- SUBJECT:** Hartzell Engine Technologies (HET) Alert Service Bulletin (ASB) No. 081A
- PURPOSE:** To notify owners, operators, distributors, and maintenance facilities of inspection criteria for affected Hartzell alternators; Continental P/Ns 641668, 641670, and 656802.
- COMPLIANCE:** Compliance may be required prior to further flight. Reference attached Hartzell Engine Technologies (HET) Alert Service Bulletin (ASB) No. 081A.
- MODELS**
- AFFECTED:** New and rebuilt Continental GTSIO-520-C, N; IO-520-B, BA, BB, C, CB; IO-550-A, B, C, G, N, P, R, IOF-550-B, C, N; TSIO-520-B, BB, D, DB, E, EB, NB, UB; TSIO-550-B, C, E, G, J, K, N; TSIOF-550-D, J, K, P and TSIOL-550-B aviation gasoline (AvGas) engines.

DOC NO **REVISION**
CSB19-06

ALERT SERVICE BULLETIN No. 081 Rev. A

Alternator Castellated Hex-Nut Inspection

Figure 1 - Alternator, Typical - Continental Aerospace Technologies

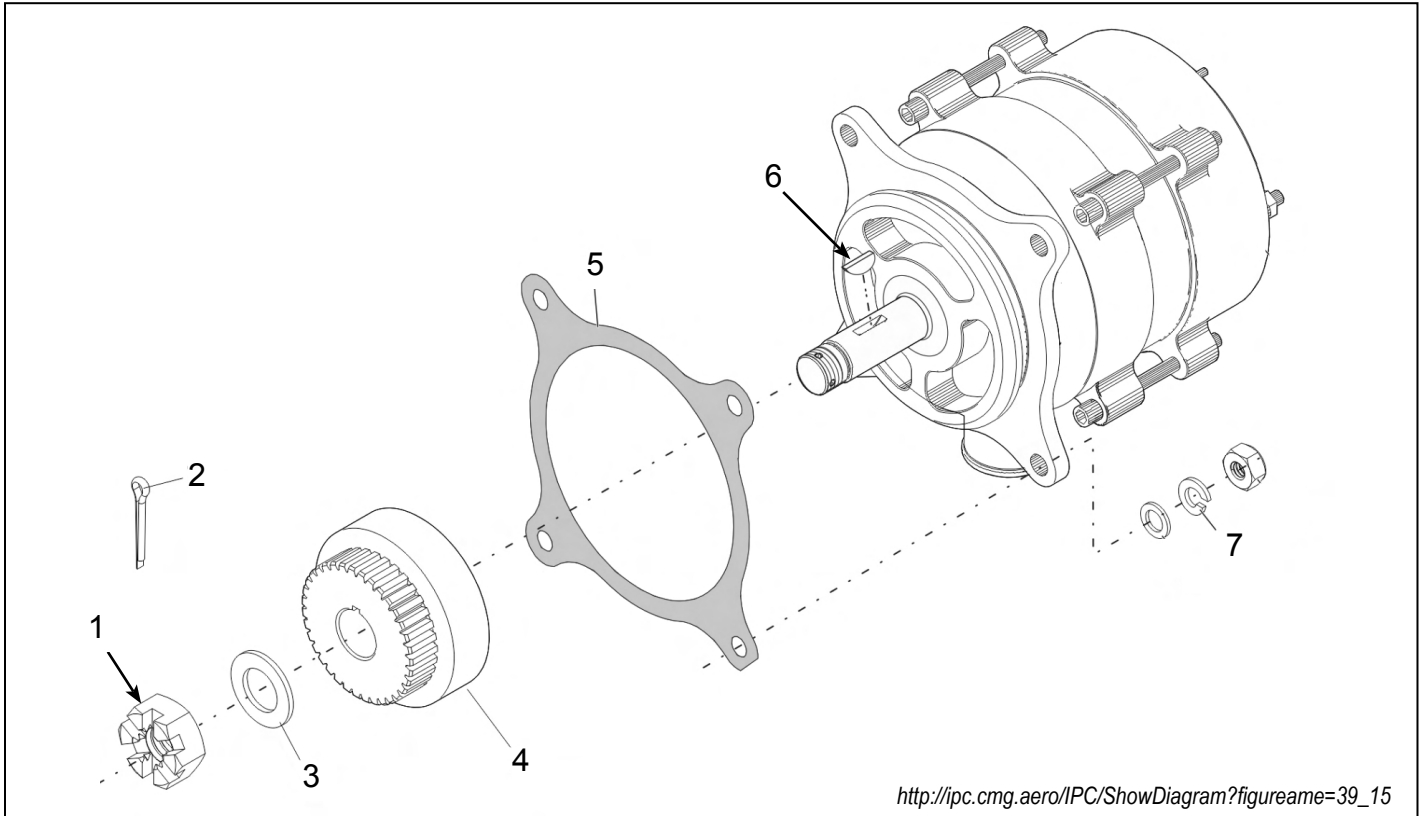
4. This revision is issued to change the following:
 - A. Correct part number typo, Table 1, Materials Required:
 - (1) Change thrust washer P/N 63097 to 63091 (Table 1, ITM# 3).

- (1) Alternators listed in section 1.A could contain a castellated hex-nut (1, Figure 1) that does not torque flush with the thrust washer (3). This condition could compromise the integrity of the drive coupling retention system.
 - (a) Loss of drive coupling retention may result in engine damage and/or unexpected loss of engine power.
- (2) This ASB is to advise the field of a known condition and to supply inspection criteria to identify affected alternators.

- (5) Remove and discard from alternator; cotter pin (2), castellated hex-nut (1), thrust washer (3), and woodruff key (6). Refer to Figure 1.
- (6) Inspect drive coupling (4) in accordance with applicable service instructions.
- (7) Install new replacement components not affected by this ASB onto the alternator in accordance with applicable engine manufacturer's maintenance manual. Refer to Table 1 - Materials Required.

Figure 4 - Roll-Stamped "AD"

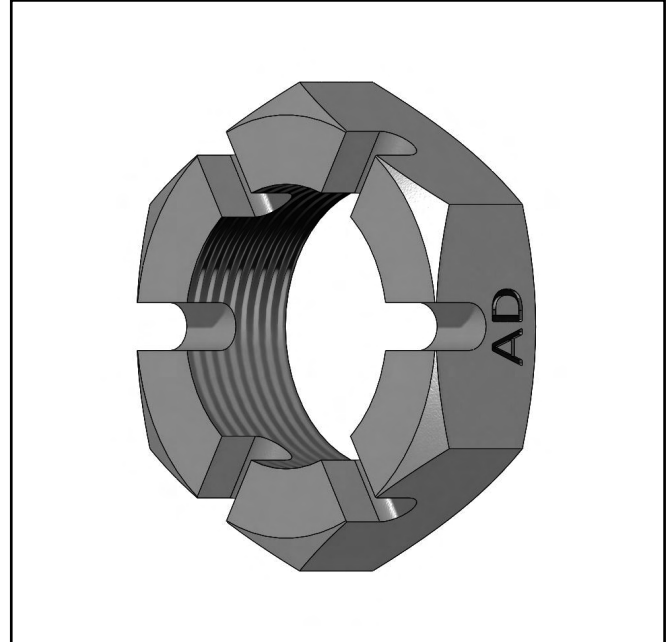
- B. Revise 3.B.2.(c) to reflect change to Figure 4:
 - (1) Change to: Hex-nut (1) is roll-stamped with the letters "**AD**".
 - C. Add task 3.B.(6) for clarification:

- (1) Inspect drive coupling (4) in accordance with applicable service instructions.
 - D. Change Figure 4 from Machined Groove to Roll-Stamped "**AD**" and update illustration.

Figure 5 - Center-Punch Mark

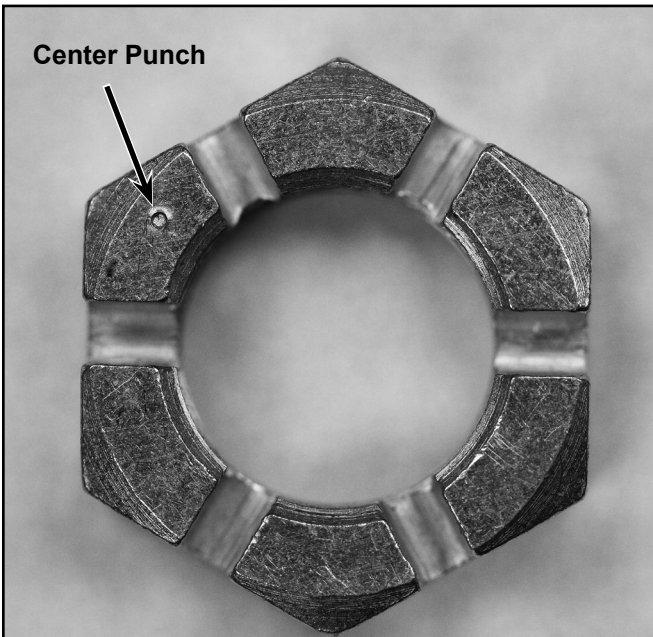
- (a) If the measurement at any nut flat is \geq .002 in. (.0508 mm), continue to 3.B.(5).
- (b) If the measurement at each nut flat is $<$.002 in. (.0508 mm), no corrective action is required.
 - 1) Using an automatic center punch, punch the face of the hex-nut (1) so that it will be easily identified for future reference (Refer to Figure 5). Continue to 3.B.(8).

Figure 6 - Gap Measurement

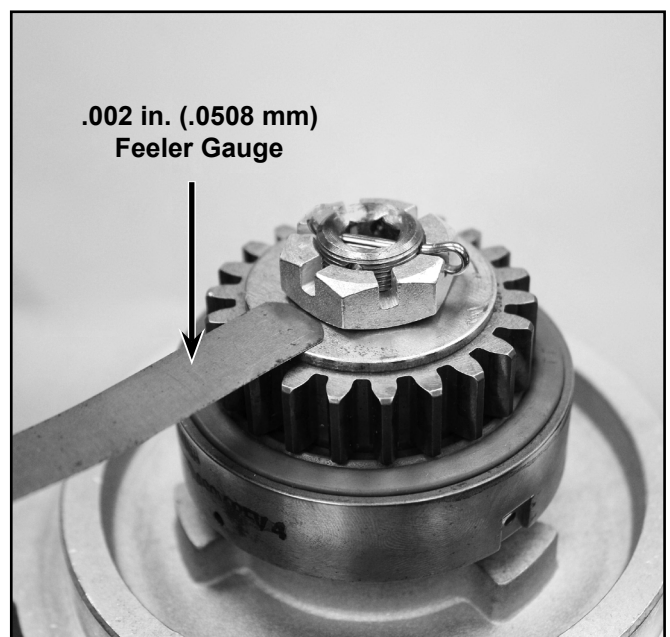
- (1) Remove the alternator from the engine in accordance with the latest revision of the aircraft and/or engine manufacturer's maintenance manual.
- (2) Inspect castellated hex-nut (1). If one of the following indicators is present, the alternator is in compliance with this ASB. Refer to Figures 3 thru 5.
 - (a) Hex-nut (1) is laser etched with the letter "H";
 - (b) Hex-nut (1) is stamped with a center-punch;
 - (c) Hex-nut (1) is roll-stamped with the letters "AD".
- (3) If any indicator stated above **is not** present, proceed to 3.B.(4). If one of the indicators stated above **is** present, continue to 3.B.(8).
- (4) Using a .002 in. (.0508 mm) feeler-gauge, measure the gap between the nut thrust face and the thrust washer at each of the six hex-nut flats. Refer to Figure 6.
